GOVERNMENT OF THE DISTRICT OF COLUMBIA
DEPARTMENT OF TRANSPORTATION

MEMORANDUM

SUBJECT: ZC Case No. 16-23 – The Lady Bird

Figure 1 – Site Plan (Source: CTR, Gorove/Slade, Figure 8, 11/22/17)

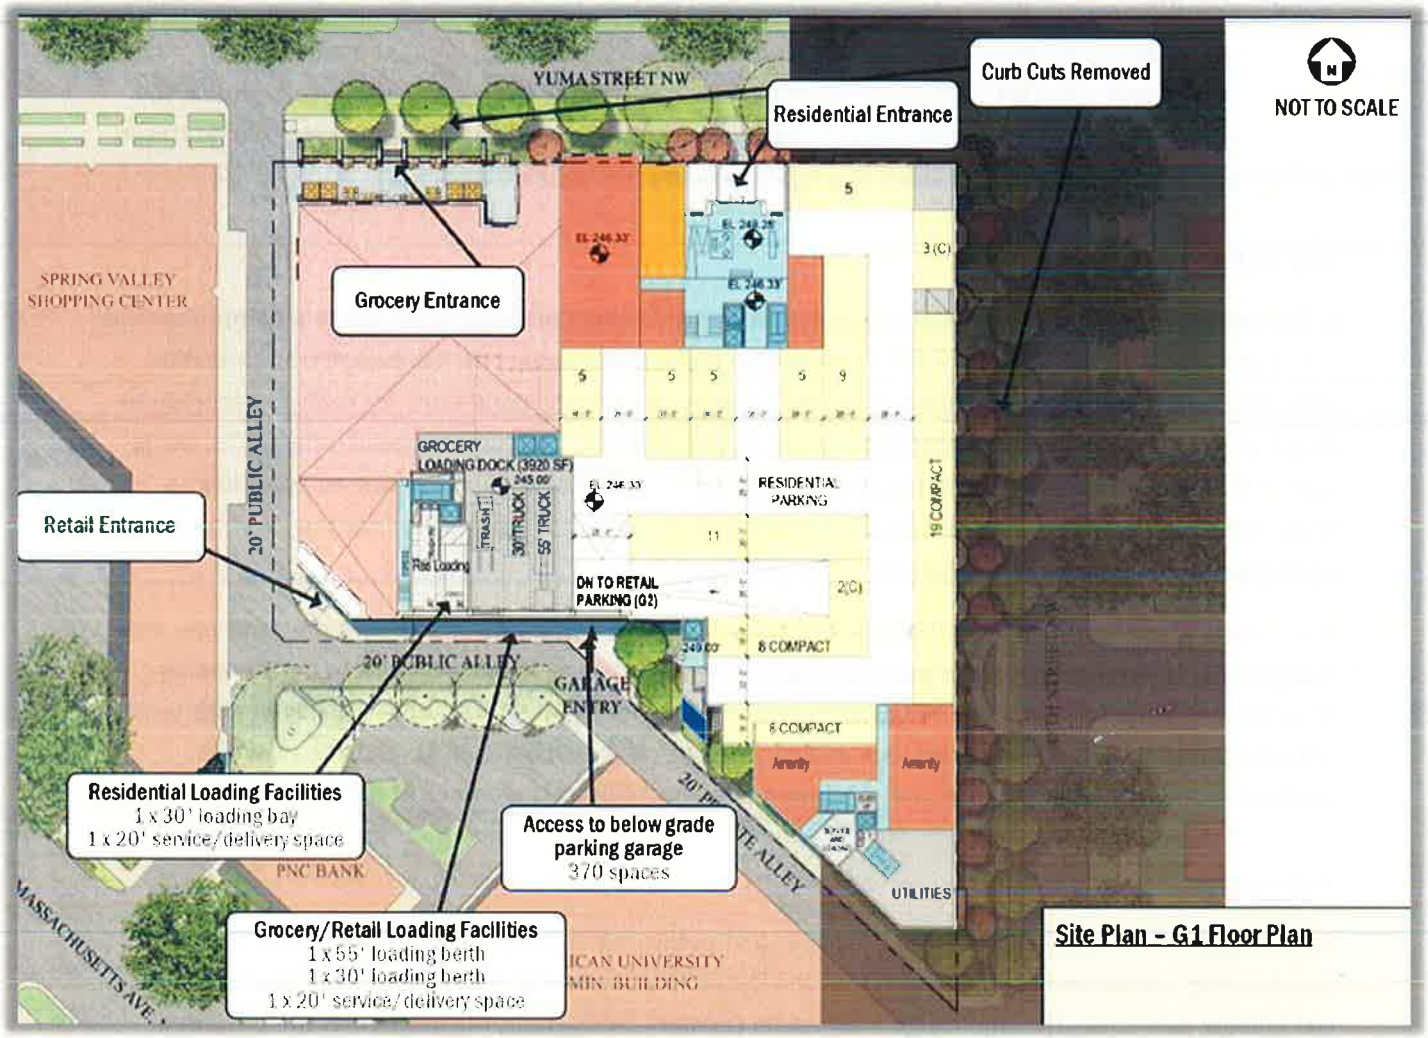
DDOT is in concurrence with the proposed loading scheme as shown in Figure 1, so long as the loading management plan discussed above is in effect and the Applicant adds the following additional items:

While the preliminary public space plans, shown above in Figure 1, are generally consistent with DDOT standards, there are several considerations that need to be incorporated and items to be reviewed in greater detail during the public space permitting process:

- The existing Yuma Street NW alley curb cut and apron should be shifted to the east to be consistent with the new alignment of the alley;
- DDOT concurs that the existing curb cuts on Yuma Street and 48th Street NW should be closed and replaced with green space and street trees;

- The sidewalk clear zone width on Yuma Street NW is proposed to be 8-feet near the grocery store entrance and then narrowed to 6-feet along the residential portion of the project. The edge of sidewalk should maintain a straight line along the northern edge of the sidewalk;

- An occupancy permit will be required for the outdoor café seating currently shown in public space near the Yuma Street NW grocery store entrance;
- Building projections on Yuma Street NW should not project more than 4-feet into public space;

- The concrete strips running north-south in the middle of the green space near the grocery store entrance on Yuma Street NW should be removed;
- DDOT finds the design of the proposed trash enclosures along the public alley appropriate and will require a public space occupancy permit;

- All dumpsters currently located in public space along Yuma Street west of the alley and east of Exxon, which is within this Design Review application's plan area, should be moved to the new enclosures in the public alley; and

- There are several segments of pavement in public space along Yuma Street west of the alley and east of Exxon. These areas should be restored to green space with leadwalks connecting from the sidewalk to building entrances.

- The loading management plan shall also apply to the Spring Valley Shopping Center site;
- All trash bins an dumpsters currently located along Yuma Street NW will be relocated to the alley and placed in the proposed enclosures; and
- Trucks traveling to the Spring Valley Shopping Center will be directed not to pick-up or drop-off on Yuma Street NW and will be directed to use the rear alley network.

Figure 2 – Proposed Alley Improvements (Source: CTR, Gorove/Slade, Figure 10, 11/22/17)

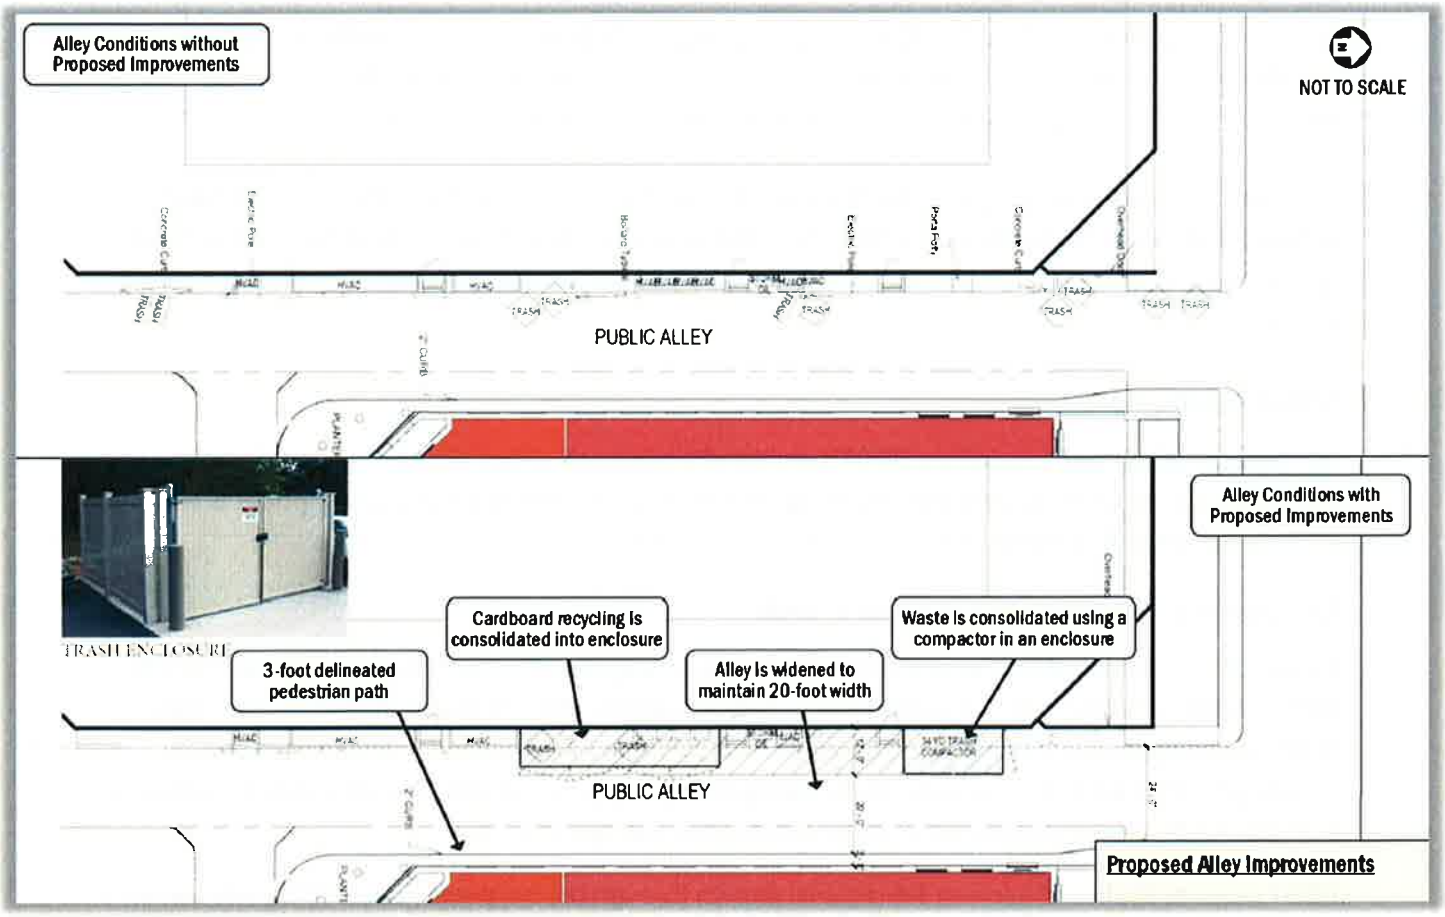
- The site is served by a mostly complete but not up-to-standards pedestrian network;
- DDOT concurs with the Applicant's proposal to enclose trash containers along the north-south alley and widen the alley by approximately 7 feet onto private space so long as the widened alley segment is within a public access easement, a public space occupancy permit is obtained for the trash enclosures, and the alley curb cut on Yuma Street NW is shifted to the east to be consistent with the re-aligned alley; and

As shown below in Figure 2, the Applicant has proposed to enclose the trash containers from the Spring Valley Shopping Center that are currently partially sitting in the public alley. The containers currently occupy approximately 5 feet of private space west of the alley and 7 feet of public space within the alley. In order to keep the full 20-foot width of the alley, the Applicant plans to widen the alley by 7 feet on private property to the east. DDOT concurs with the Applicant's proposal so long as the widened alley segment is within a public access easement, a public space occupancy permit is obtained for trash enclosures, and the alley curb cut is shifted to the east to be consistent with the new alley alignment.

Figure 5 – Existing Pedestrian Infrastructure (Source: CTR, Gorove/Slade, Figure 33, 11/22/17)

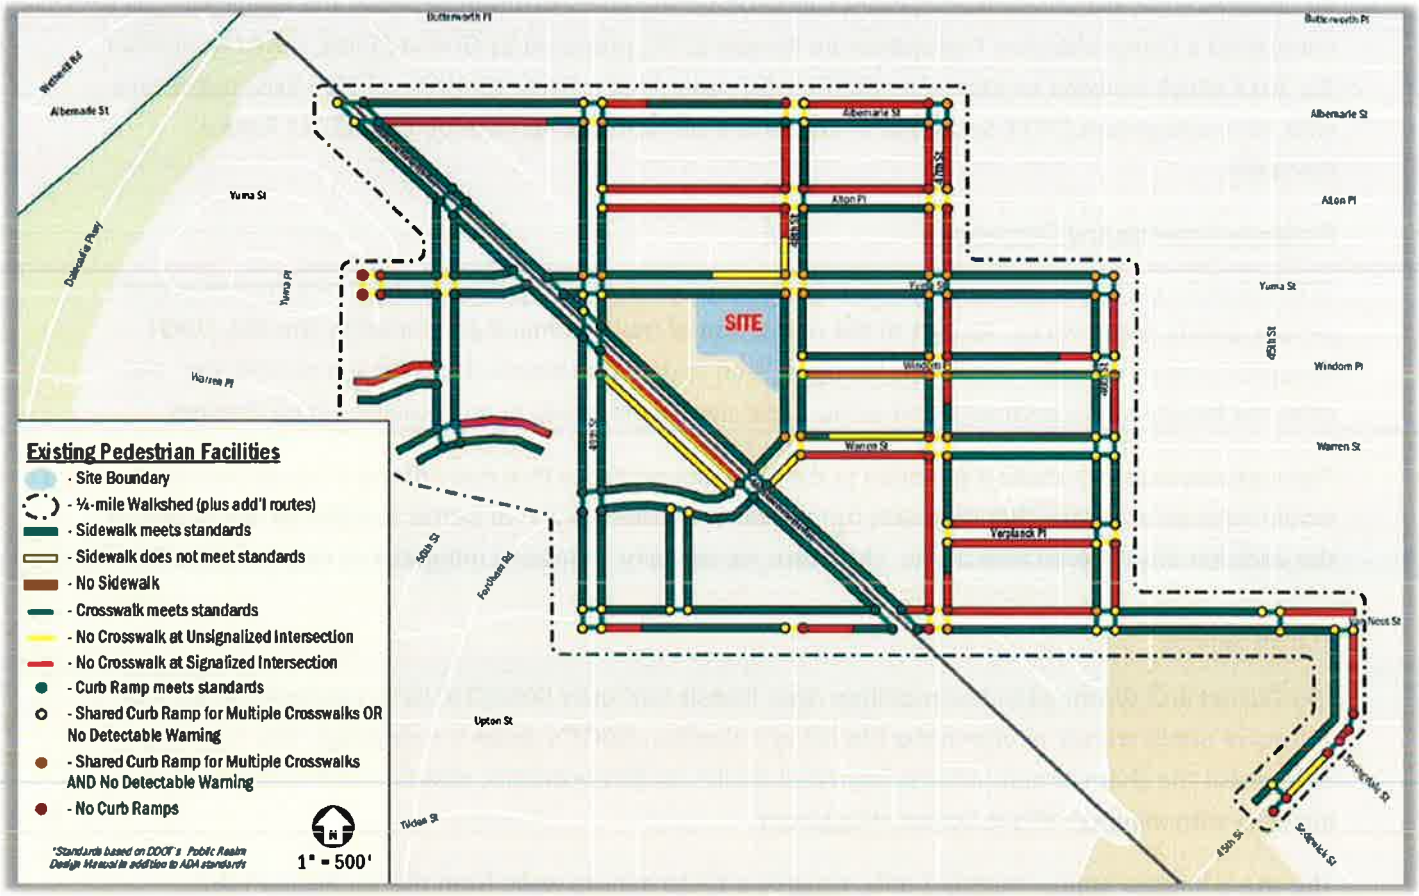
The Applicant's inventory of existing pedestrian infrastructure, as shown in Figure 5 below, demonstrates that most sidewalks in the immediate vicinity of the site are currently constructed with appropriate widths. However, there are numerous curb ramps that do not meet DDOT standards and should be upgraded. While there are a few missing or substandard segments of sidewalk and curb ramps in the broader area, the existing pedestrian network along major pathways to schools, attractions, and the Metrorail station is generally adequate.

DDOT expects that the Applicant will reconstruct the public space along the frontage on both Yuma Street (from the Exxon driveway east to 48th Street NW) and 48th Street (from Yuma Street south to the Warren Street NW) and upgrade any pedestrian facilities to current DDOT standards. Additionally, several submitted drawings show sidewalks constructed along the alley connection from Massachusetts Avenue NW. DDOT expects at a minimum a sidewalk will be provided along the western side of the alley until it reaches the trash enclosures at the rear of the Spring Valley Shopping Center.

As discussed previously in the Vehicle Parking section, to offset the impacts of being over-parked, DDOT recommends the Applicant fund and construct several pedestrian network improvements in the immediate vicinity of the site to encourage walking and discourage driving. Specifically, the Applicant should upgrade sub-standard curb ramps, stripe missing crosswalks, and install curb extensions on all

corners of the following intersections. These curb extensions will make the stop signs more visible to drivers, shorten the crossing distance for pedestrians, and slow turning vehicles.

- 49th Street and Yuma Street NW
- 48th Street and Yuma Street NW
- 48th Street and Windom Place NW
- 48th Street and Warren Street NW
